# UNITED STATES PATENT AND TRADEMARK OFFICE

APPLICATION NO.	FILING DATE	FIRST NAMED INVENTOR	ATTORNEY DOCKET NO.	CONFIRMATION NO.
10/502,104	09/19/2005	Dror Shemesh	6317P076	3403
45401 7590 08/23/2007 APPLIED MATERIALS/BLAKELY 1279 OAKMEAD PARKWAY SUNNYVALE, CA 94085-4040			EXAMINER JOHNSTON, PHILLIP A	
			ART UNIT 2881	PAPER NUMBER
			MAIL DATE 08/23/2007	DELIVERY MODE PAPER

## Office Action Summary

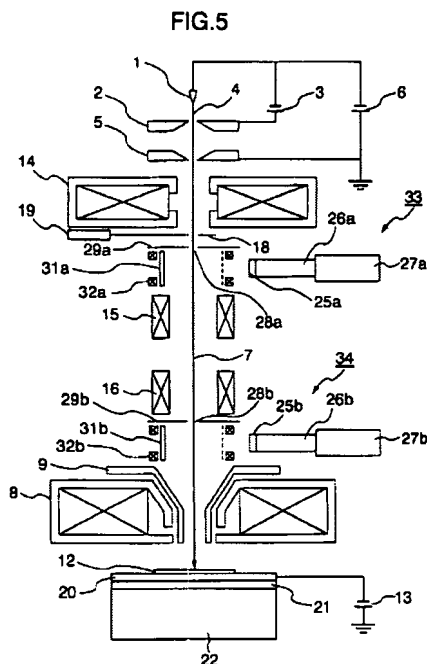
3. Regarding claim 13, Todokoro discloses a system for multi detector detection of electrons, comprising: multiple interior detectors for providing detection signals; a column through which electrons may propagate (See Figure 5 below);

Todokoro also teaches a means for directing a primary electron beam, through the column, to interact with an inspected object and for directing, by

introducing a substantial electrostatic field, electrons reflected or scattered from the inspected objects towards the multiple interior detectors (See Col. 2, line 20-26; and Col. 5, line 15-26), whereas at least some of the directed electrons are reflected or scattered at small angle in relation to the inspected object. See Col. 8, line 22-52.

It should be noted here that, Todokoro uses an electric field that reaches the surface of the wafer, which inherently implies that electrons, reflected or scattered at small angles, will also be directed up through the acceleration tube towards one of the detectors.

7. Regarding claims 6-8,18, and 20, Todokoro teaches providing electrostatic or electromagnetic deflectors before and after the diaphragm 18 (note Figure 5 above) so as to suitably deflect the electron beam to adjust its centering (tilt). Col. 5, line 15-44.

**FIG. 14B**

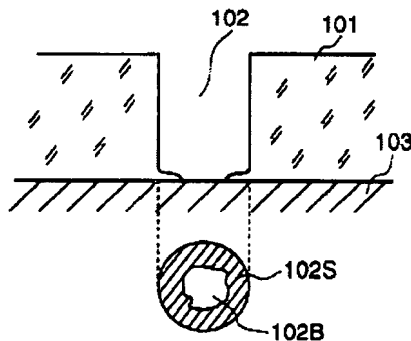
14. Todokoro (873) teaches observing residue at the bottom of a high aspect ratio contact hole. See Figure 14b below; Col. 2, line 8-18; and Col. 5, line 39-49.

15. Todokoro (873) modifies Todokoro (238) to provide a technique for displaying the condition of a contact hole formed in an insulator on the display screen of a scanning electron microscope.

16. Therefore it would have been obvious to one of ordinary skill in the art that Todokoro (238) would use the contact hole imaging technique of Todokoro (873) to provide a scanning electron microscope for observing the bottom of a contact hole formed on an observation sample such as an IC.
